RE: Shores Gravel Mine (Burch Amendment), Permit No. M-1998-013; Groundwater Mitigation Plan

RE: DRMS TR-2 Groundwater Review Comments via email October 29, 2014

Comments/clarifications on the GW Mitigation Plan submitted with TR02 responses - Please address:

<p>CIVIL RESOURCES, LLC</p> <p>DATE: 5/20/14 REVISED: 10/20/14</p>	<p>BESTWAY CONCRETE SHORES SAND & GRAVEL MINE BURCH AMENDMENT</p> <p>FIGURE: 2</p> <p>WELL USERS & GROUNDWATER MAP</p>
--	--

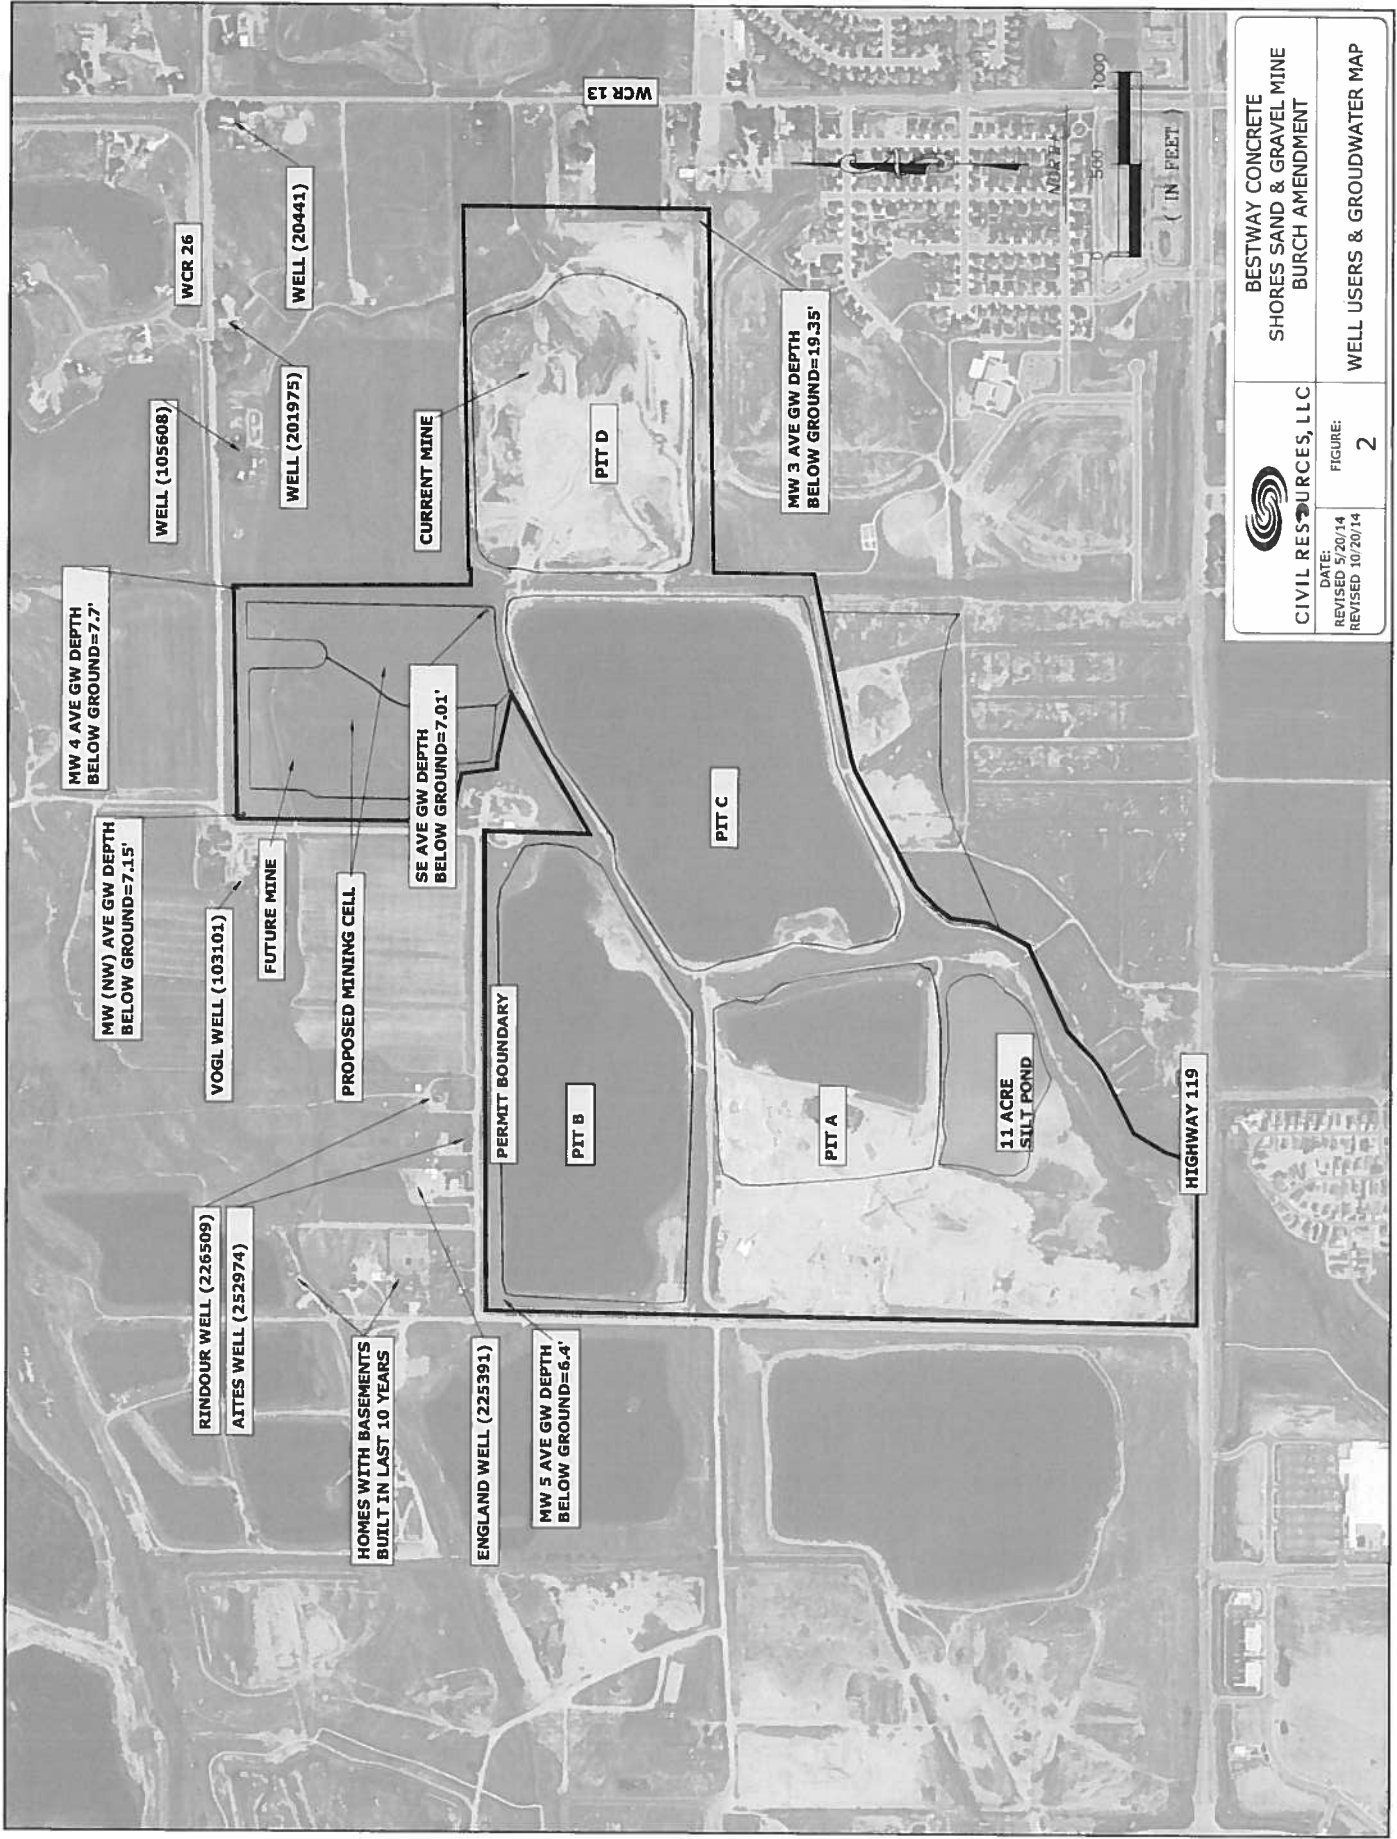
- There is a reference to a Figure 1 about halfway through the third paragraph of the second page - there is no Figure 1, so I presume you mean Figure 2? Please clarify/correct.

- Please edit the Figure 2 map to clearly show the revised post-amendment permit boundary on the south side of the site.

The Figure has been updated and is labeled as Figure 1. See attached.

The Figure has been updated and is labeled as Figure 1. See attached.
